**DEPARTMENT OF TRANSPORTATION  
STATE OF GEORGIA**

**FILE:** EDS-84(26), HPPN-EDS-84(27) & NHN-007-03(28) **OFFICE:** Eng. Services  
Ware County  
P.I. Nos.: 522770, 522780 & 522775  
S.R. 38/U.S. 84 Widening/Reconstruction and Bridge Replacement

**SUBJECT: IMPLEMENTATION OF VALUE ENGINEERING STUDY ALTERNATIVES**

# VALUE ENGINEERING STUDY REPORT RESPONSES

VE Comment A-2  
Option 2

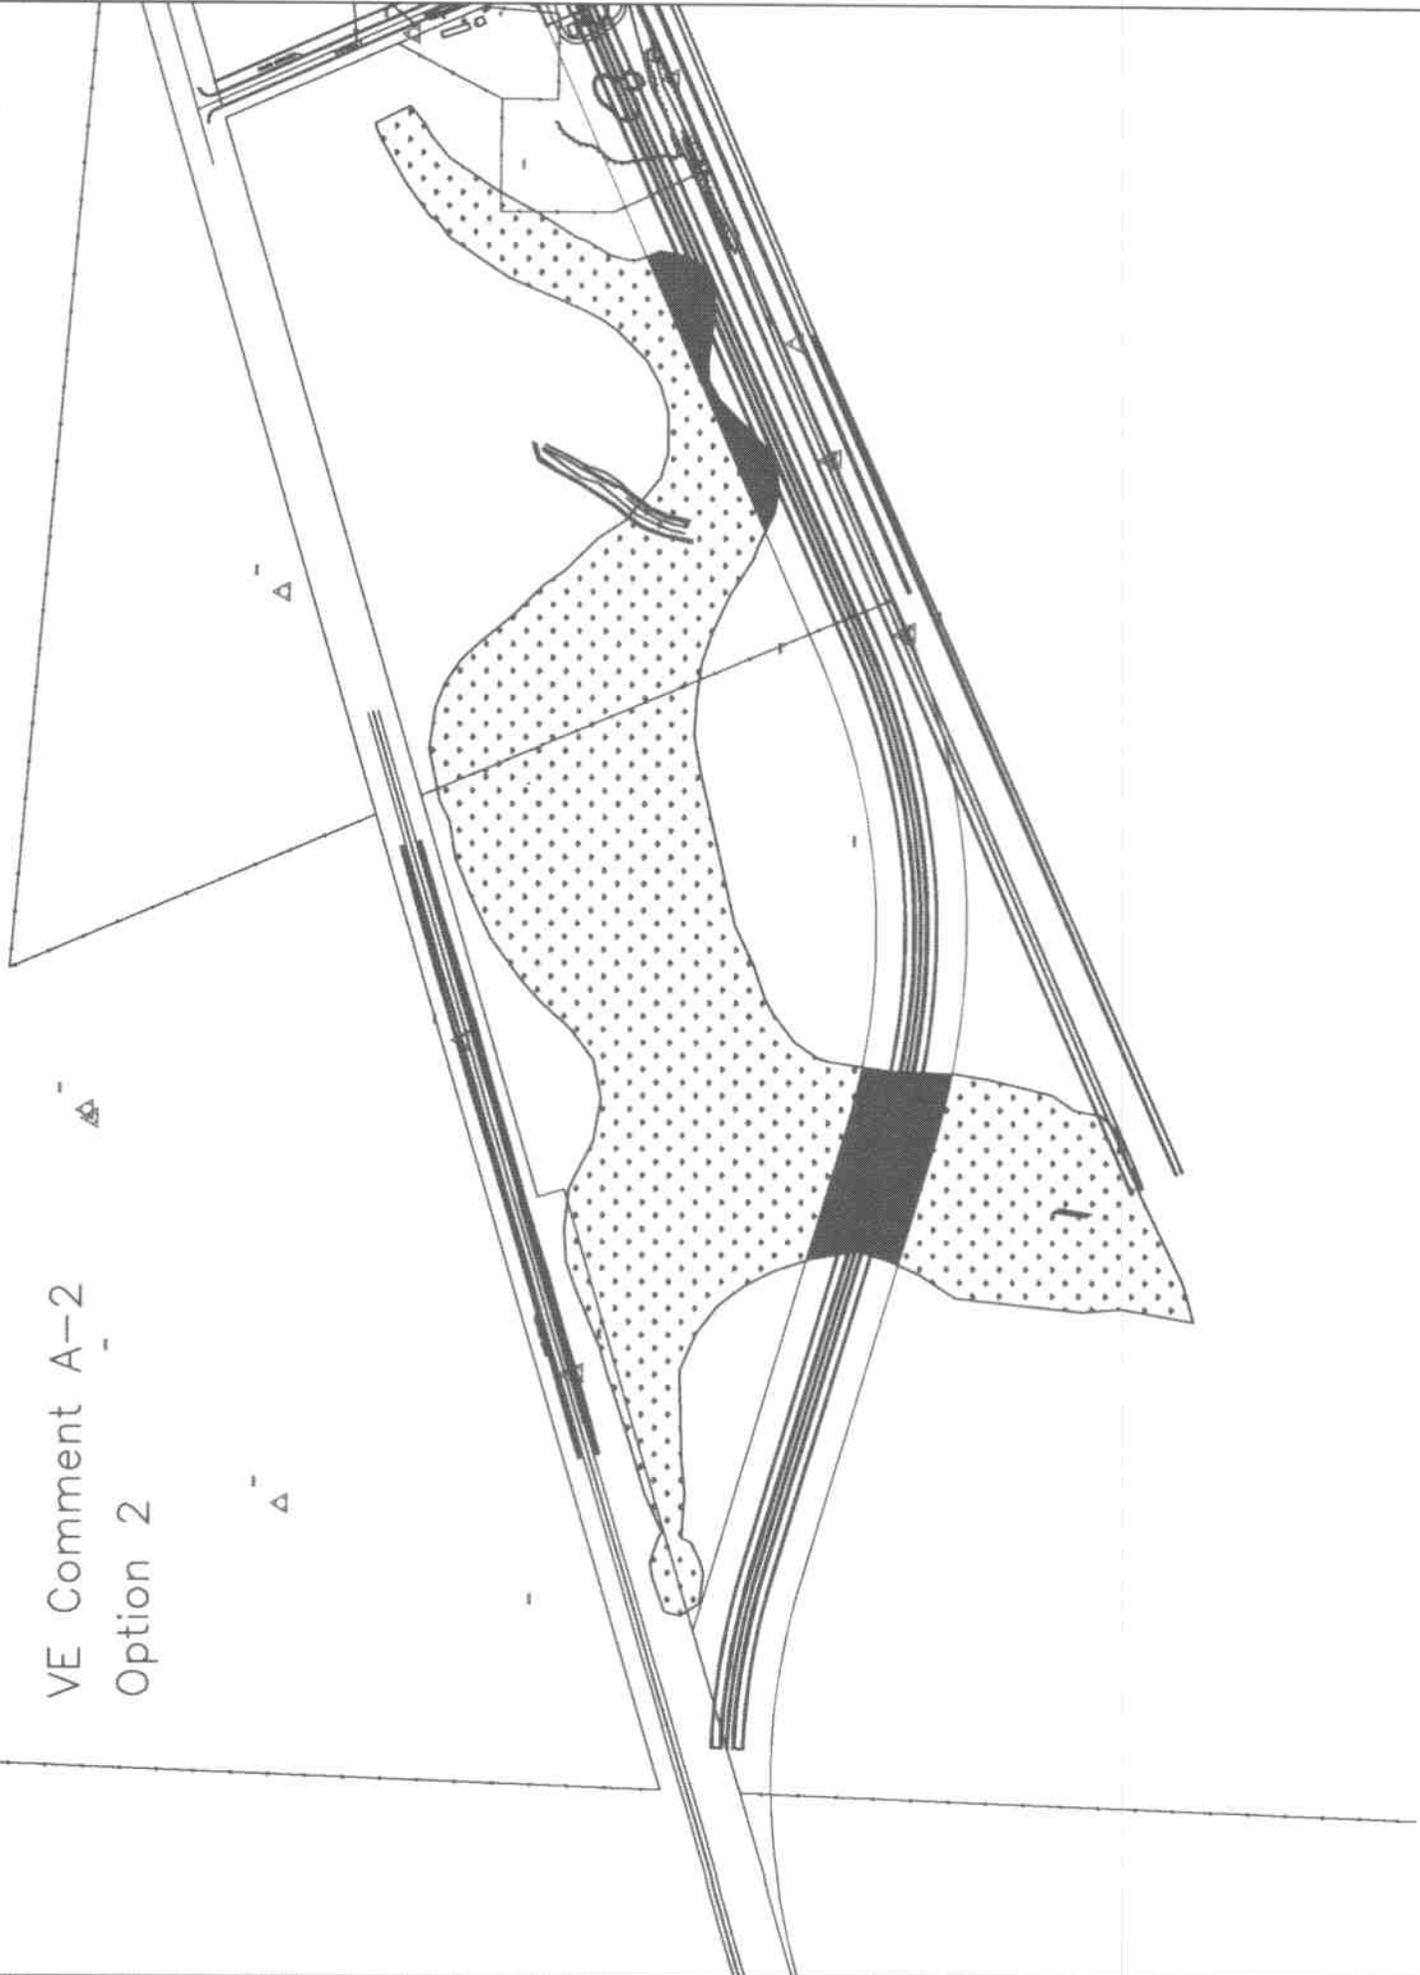
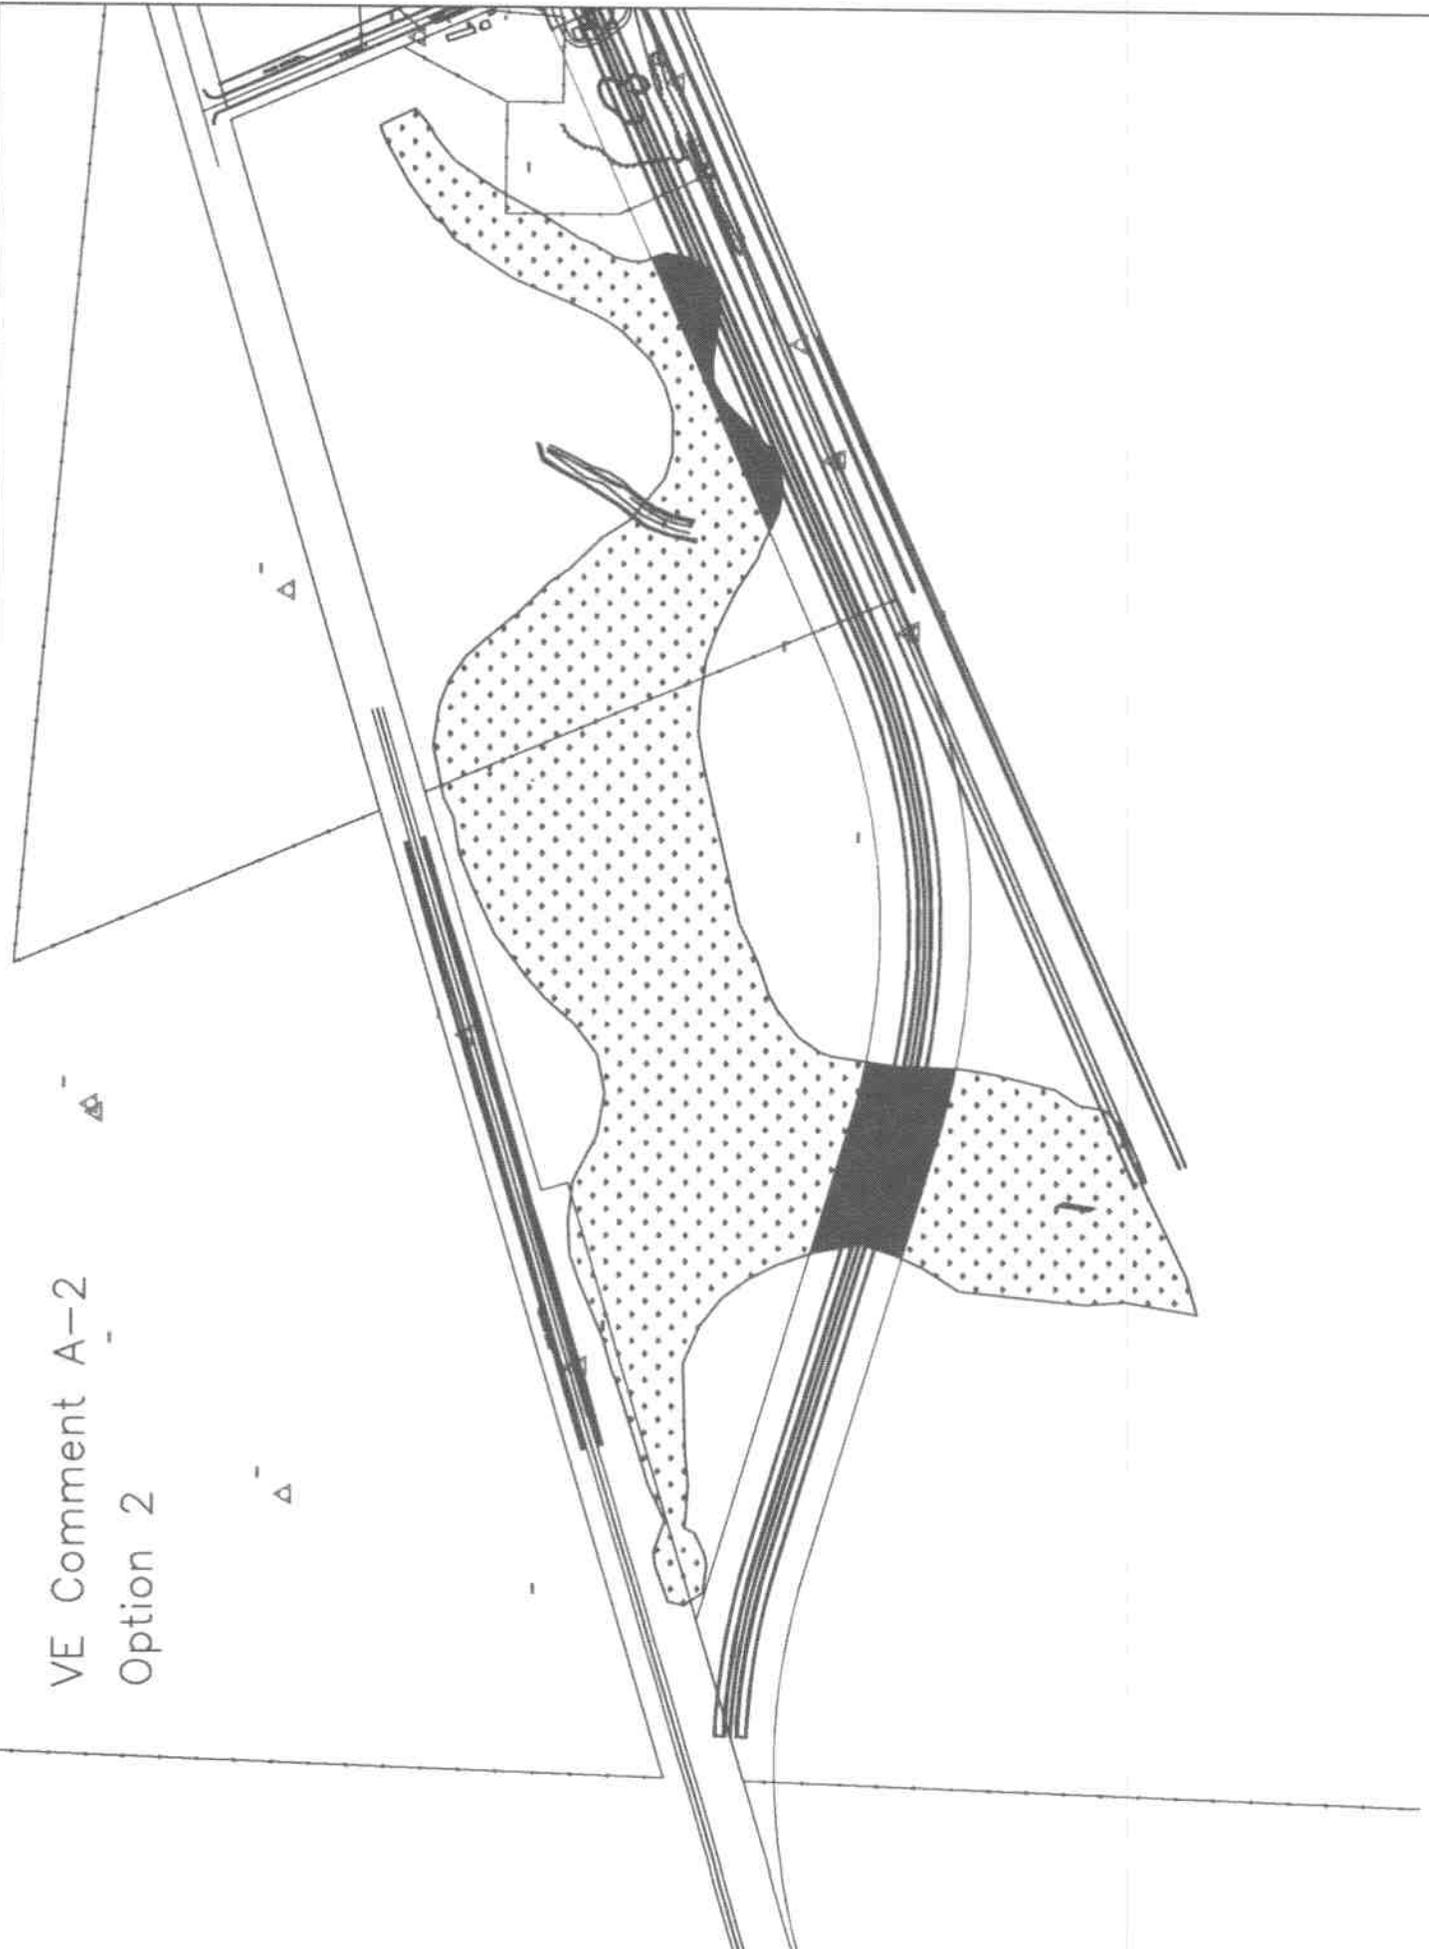
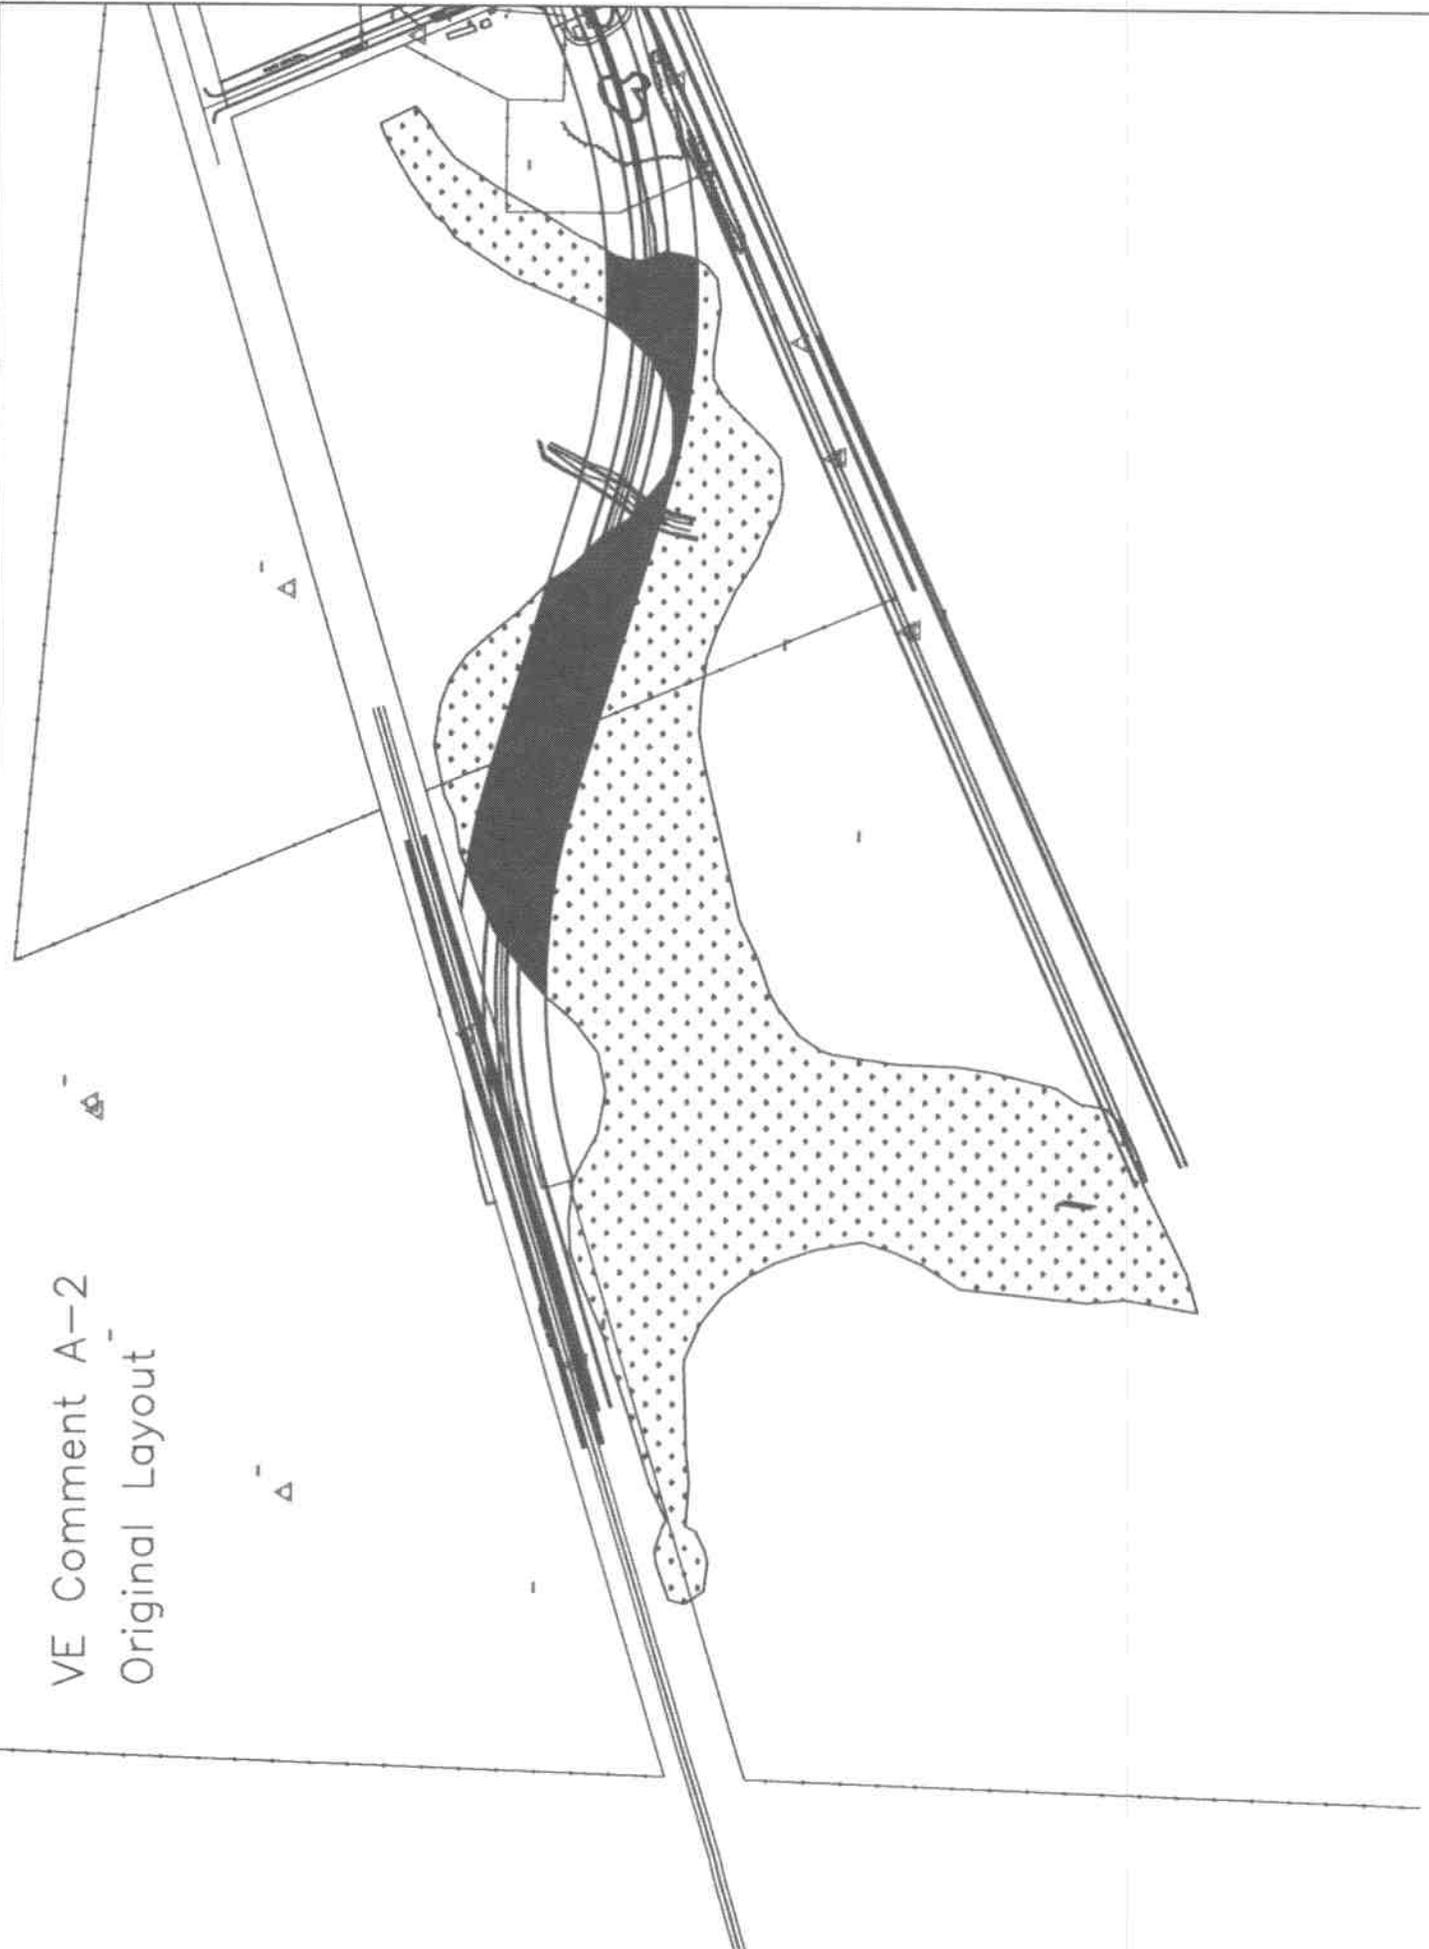
A-2 Reduce impacts to wetlands with new alignment at west end (increase wetlands identification) DS

The wetland areas shown on the plans are not inclusive of all areas other than those impacted by the original corridor. The actual area of wetlands in the surrounding vicinity is much larger. Therefore if the alignment were to be relocated as suggested by this comment, the impacts to wetlands would not be decreased as significantly as it would appear. For the first option the reduction would be 1.73 acres and for the second option the reduction would be 3.71 acres. Furthermore, the overall project costs will be increased due to the increase in required right-of-way as well as the increase in the new location paving quantities. The increase for the first option would be \$274,235 and for the second option the increase would be \$371,700. (See A-2 attachments)
